MARCH 25, 2024

ADDENDUM NO. 1

TO CONSTRUCT **BIRKHIMER EMERGENCY OPERATIONS CENTER (EOC)
UPGRADES AND IMPROVEMENTS
PROJECT NO.: CA-202313-C
TAX MAP KEY: 3-1-042:600
Honolulu, Oahu, HAWAII**

PB106

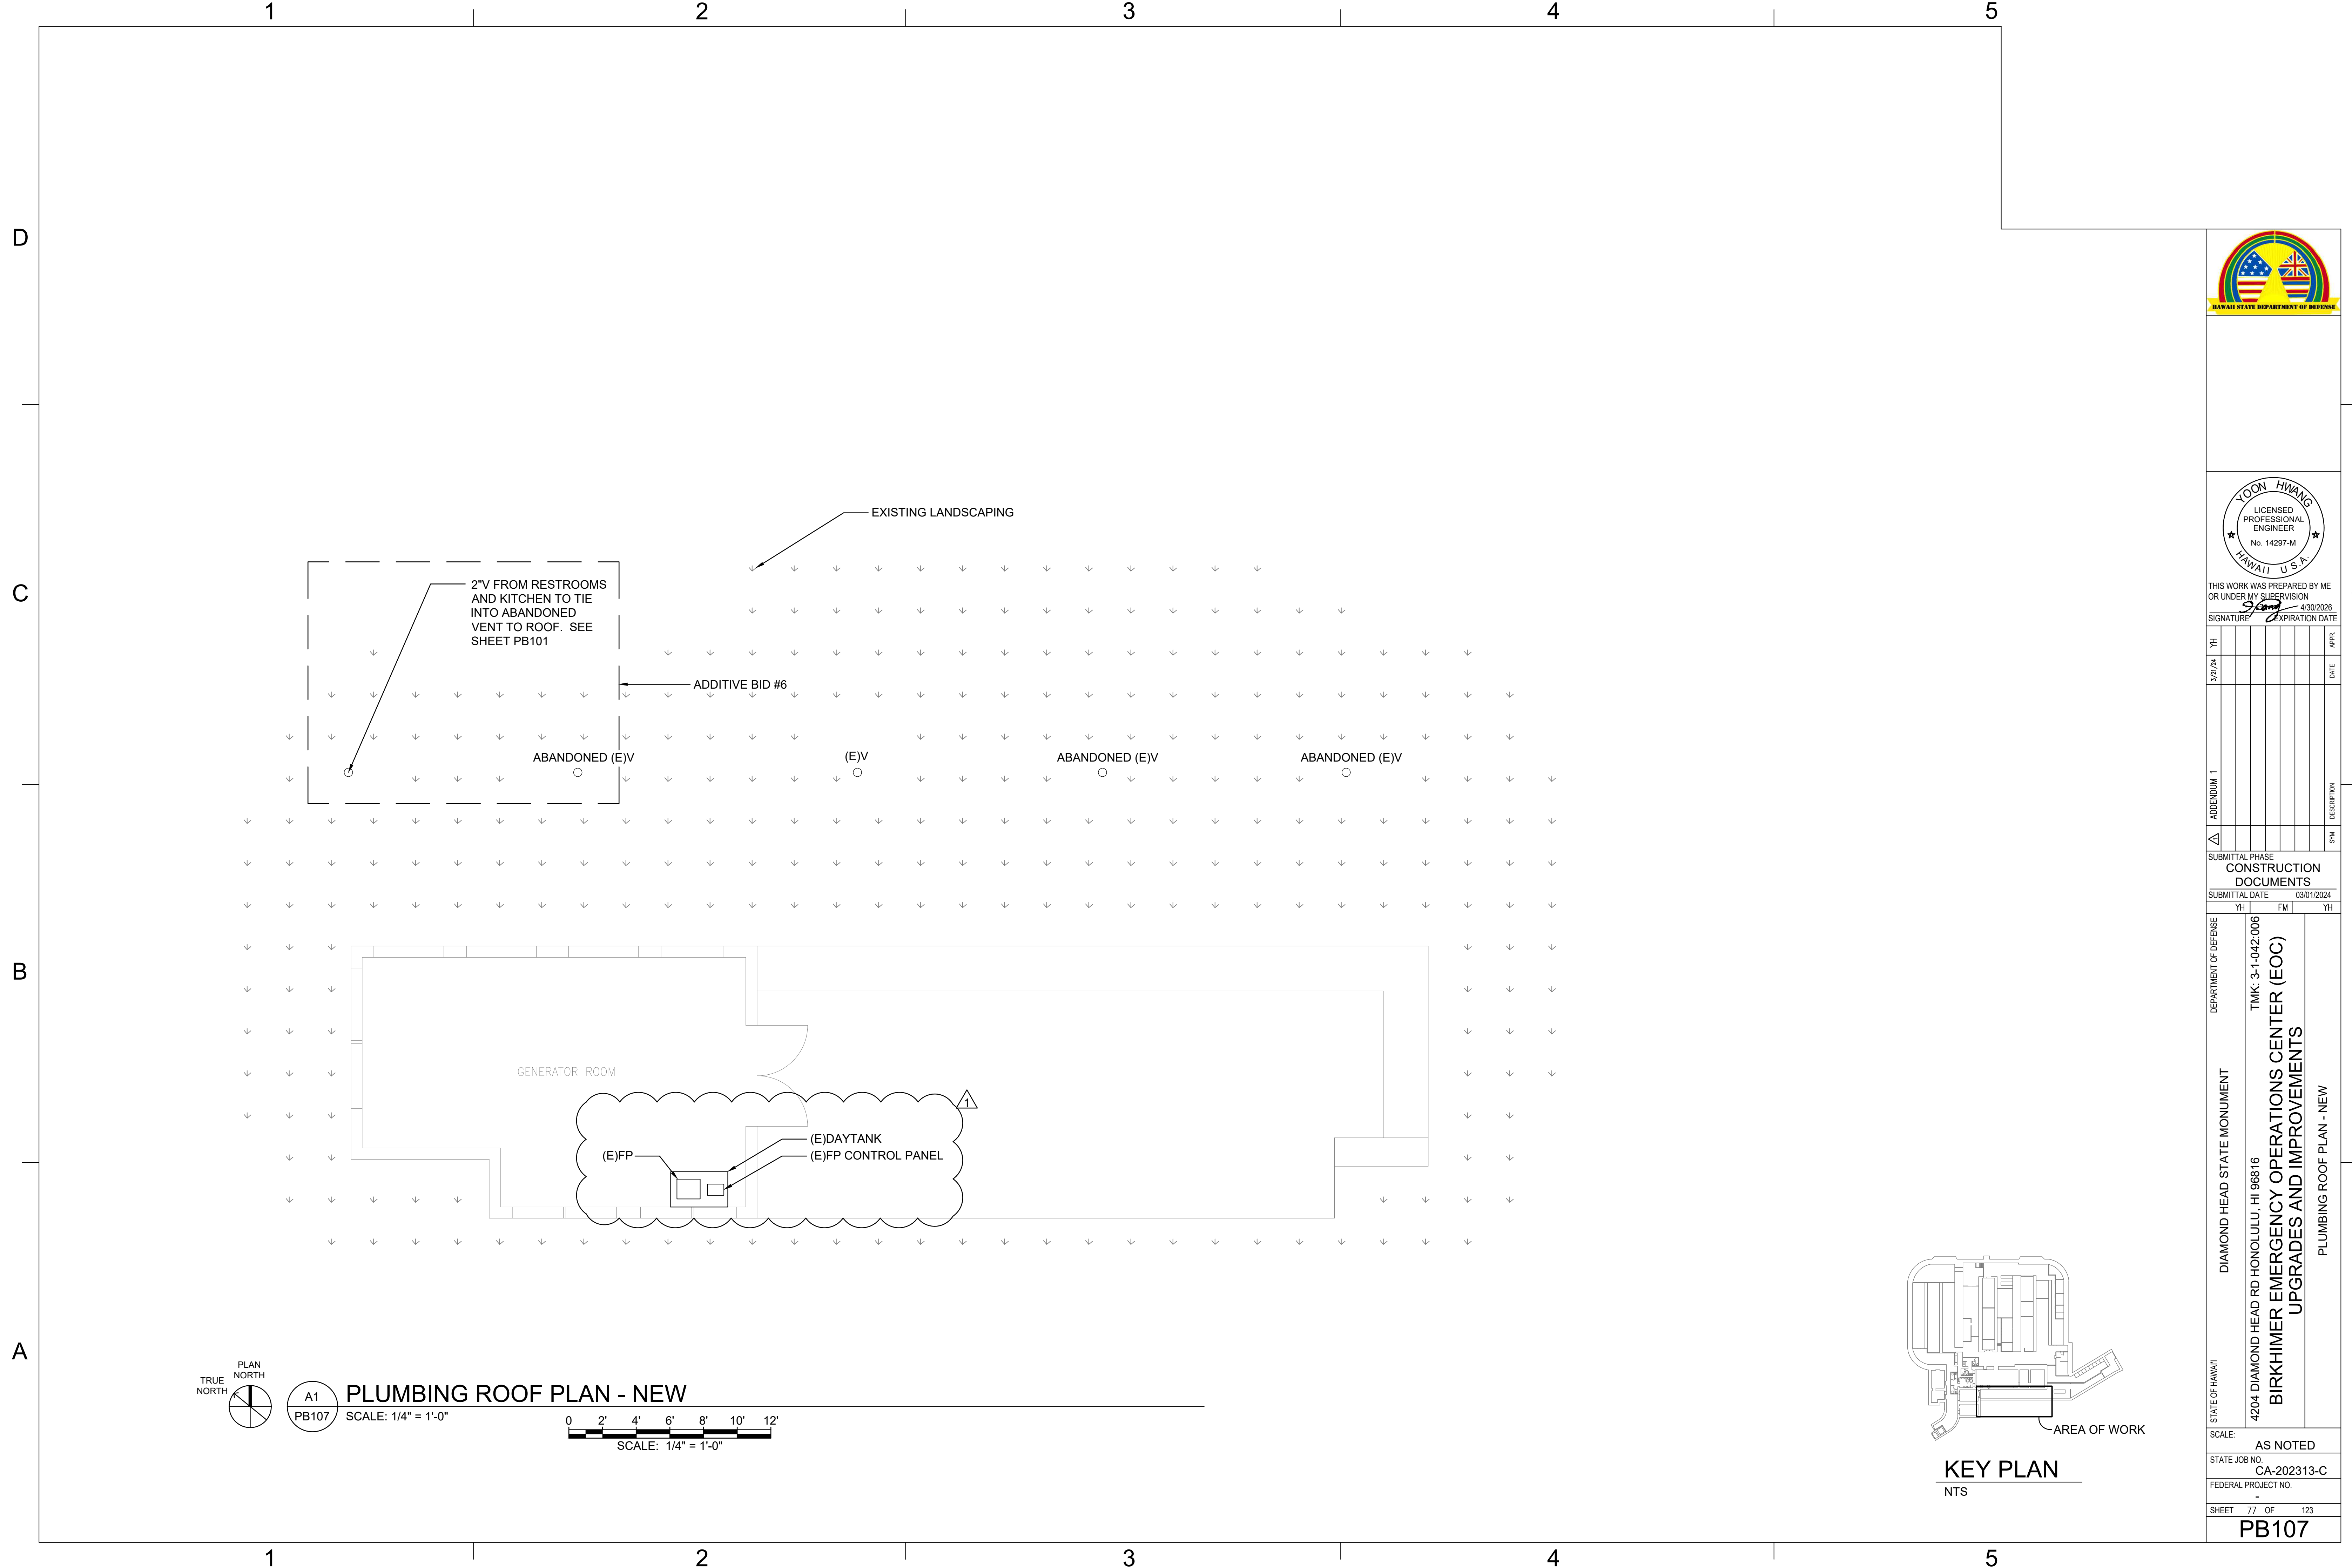
16. Drawings PB106 Fuel monitoring console	
Plans call for the existing fuel monitoring console at the Birkhimer Building to remain for reuse in addition to the new console that is to be furnished and installed. Please clarify what the existing console and new console will be monitoring.	Existing console will be replaced with new. 2nd fuel monitoring console will not be required. Refer to Addendum 1 drawings.

STATE OF HAWAII
DEPARTMENT OF DEFENSE
DIAMOND HEAD STATE MONUMENT
4204 DIAMOND HEAD RD HONOLULU, HI 96816
TMK: 3-1-042:006
BIRKHIRMER EMERGENCY OPERATIONS CENTER (EOC) UPGRADES AND IMPROVEMENTS
LIGHTING PLAN
SCALE: AS NOTED
STATE JOB NO. CA-202313-C
FEDERAL PROJECT NO. -
SHEET 93 OF 123
EA106

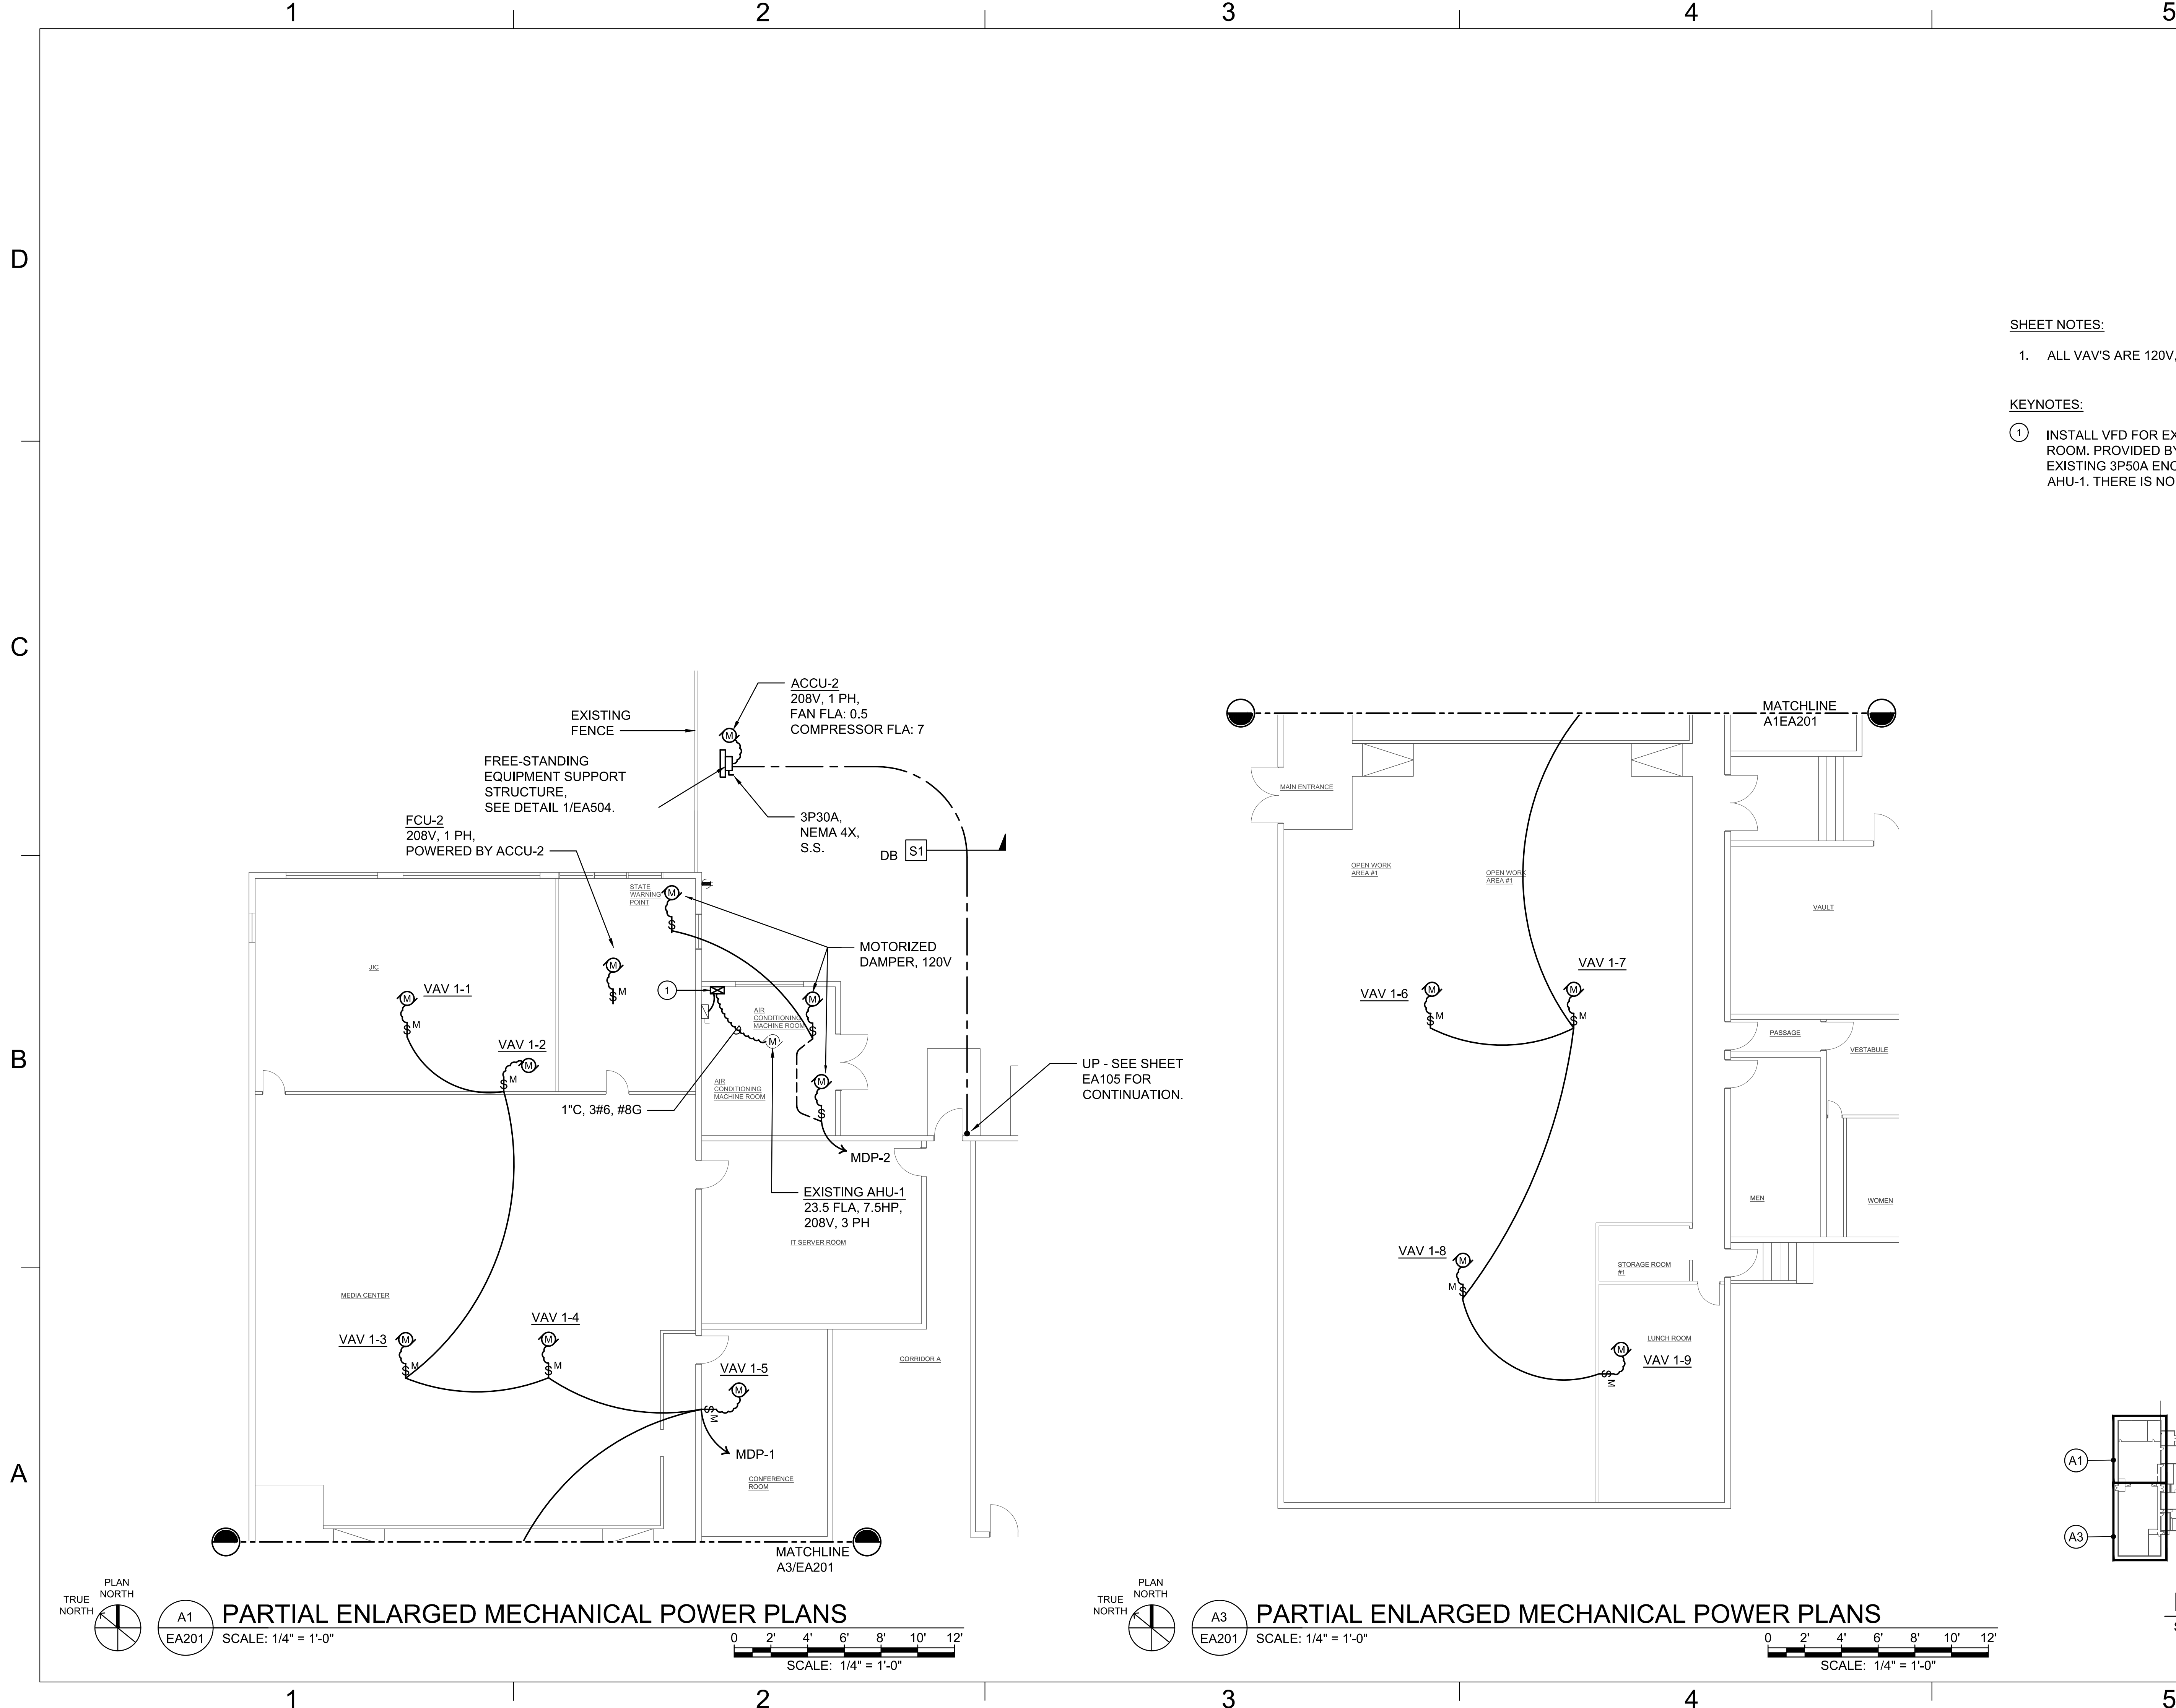
ELECTRICAL	EA106	<p>Added keynote #2 to call out "INTERCEPT EXISTING CIRCUIT VIA A JUNCTION BOX AND EXTEND TO NEW LIGHTS"</p> <p>Revised keynote callouts</p> <p>Removed occupancy sensor from switch in State Warning Point room due to lights being on 100%.</p>
ELECTRICAL	EA503	Revised wire count in duct schedule
ELECTRICAL	EA602	Revised wire count for ACCU feeder in one-line
ELECTRICAL	EA702	Add circuit to Panel PP schedule for smart water meter.
